CITY OF
West Linn
STAFF REPORT
FOR THE CITY COUNCIL

FILE NUMBER: AP-21-01
HEARING DATE: February 8, 2021
REQUEST: Appeal of the Planning Commission approval of DR-20-07/VAR-20-02/WAP-20-03 to construct/replace the existing Post Office Building with a new Post Office Building or Retail Building with a Shared Parking Area at 5665/5639 Hood Street.

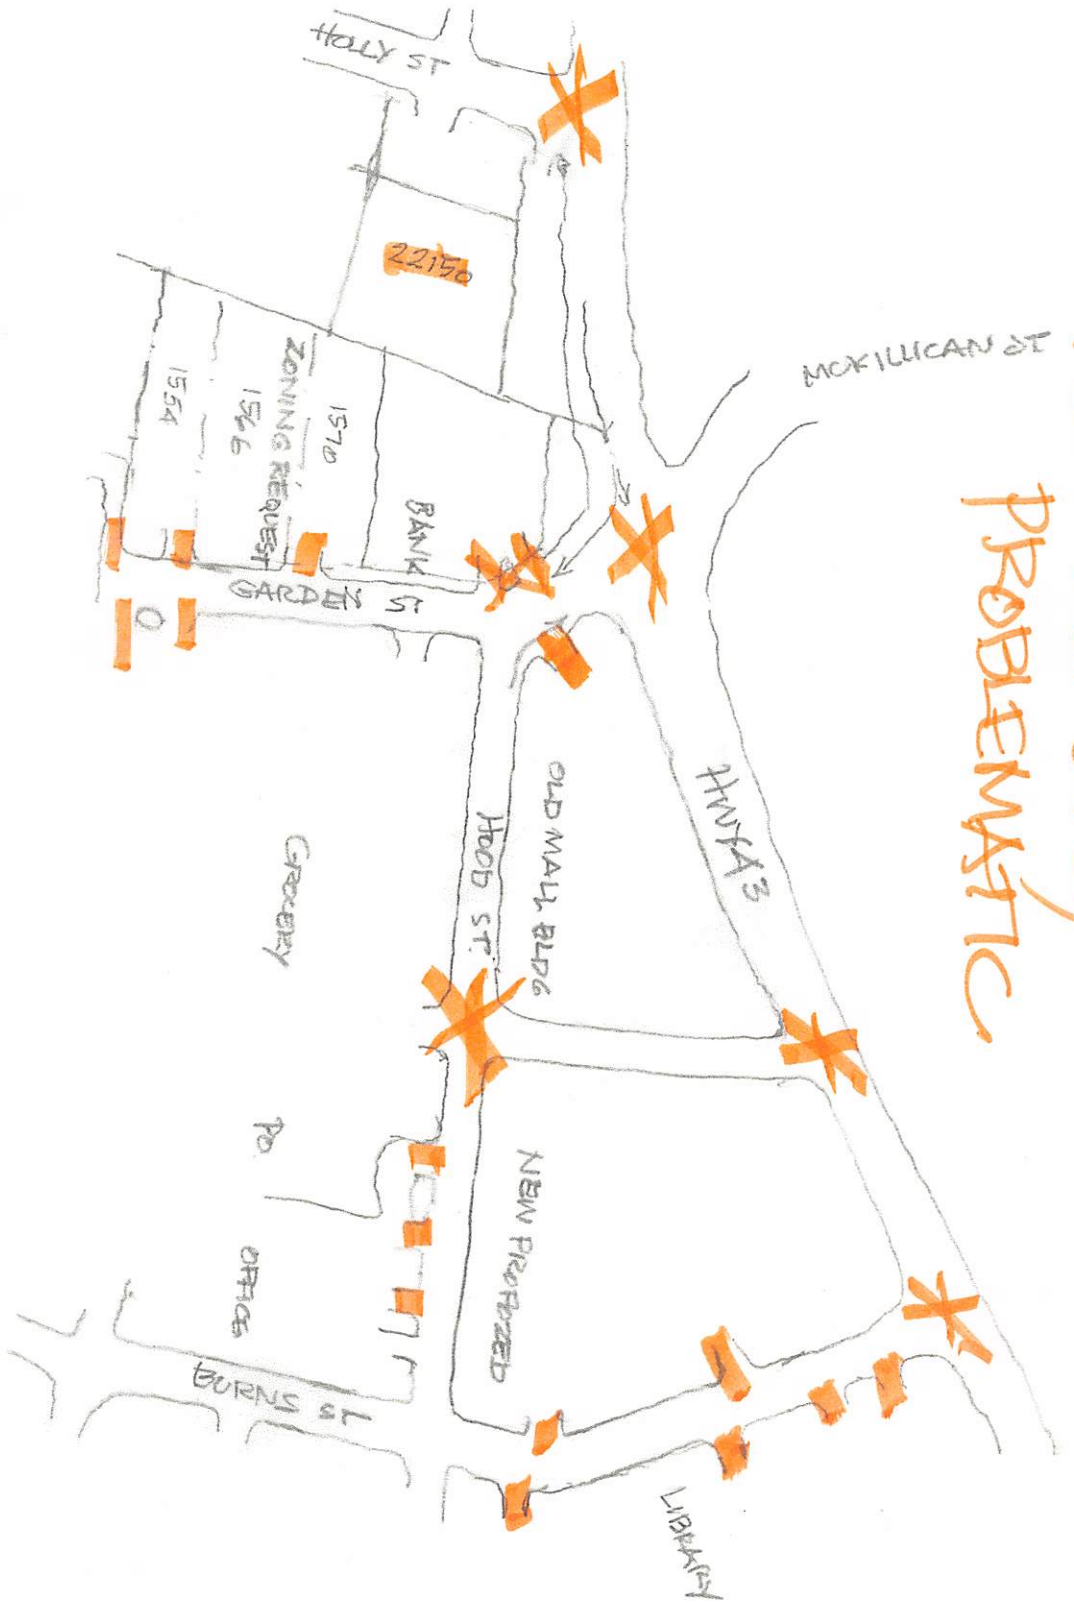
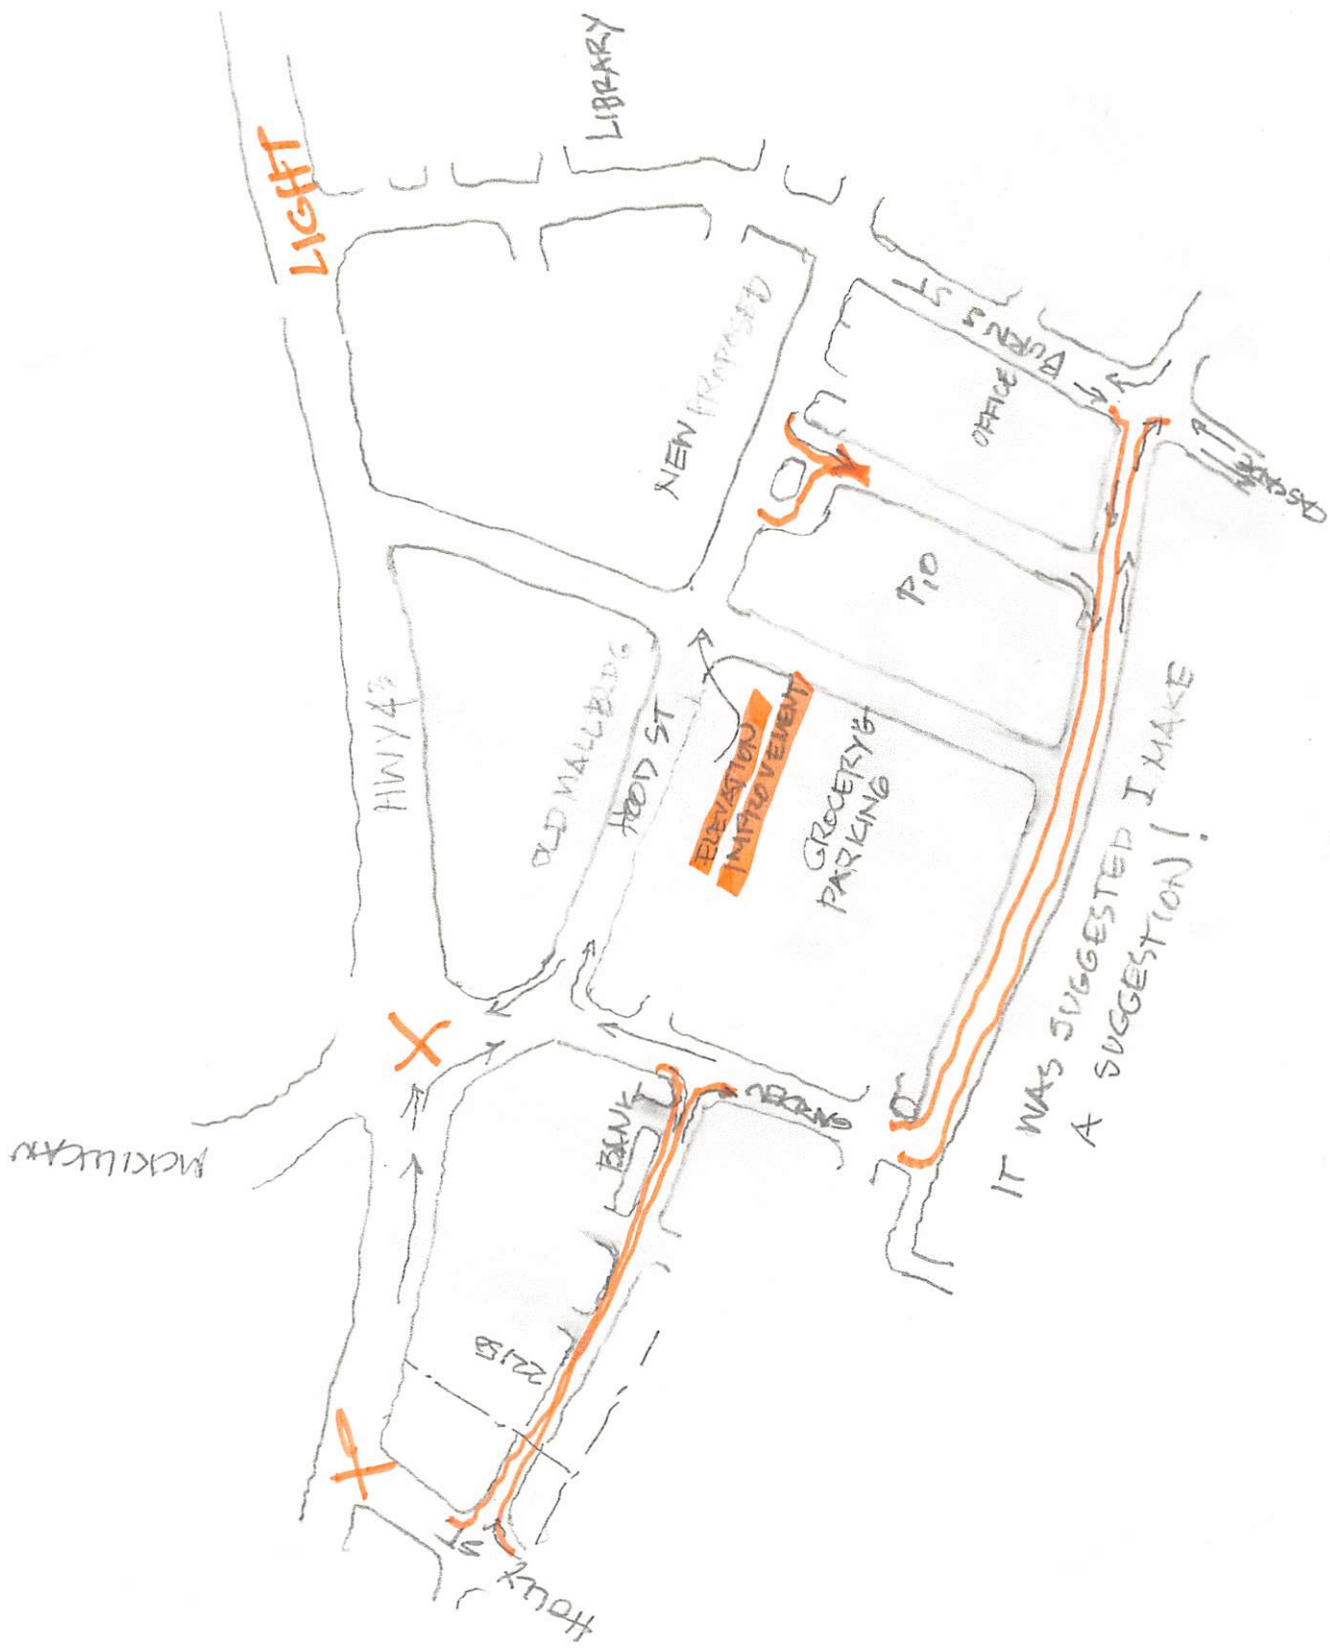
Brief Description of Proposal: REQUIRE 2-WAY STREET CONSTRUCTION ALONG EAST SIDE OF THE PROPERTY LINE TO PROVIDE A FUTURE STREET CONNECTION TO THE INTERSECTION OF CASCADE AND BURNS ST.

The Bolton Neighborhood Association proposes the street and traffic plan provided in the attached drawing. It would require the city to partner with developers, provide resources and drive a plan that integrates the Bolton Business District and improves traffic circulation.

The members of the Bolton Neighborhood support the development of a new Post Office at 5665 and 5639 Hood St. However, this design must be approved with consideration for future development on neighboring properties. Providing a transportation connection to a future 4-way intersection at Burns St. and Cascade St. must be a criterion for approval. This intersection is dependent on development plans for the current development proposed at 5639 Hood St and future development at 1564 Burns St. The current retail plan at 5639 Hood St does not build street access along the east property line to provide a future connection to a 4-way intersection at Burns and Cascade St.
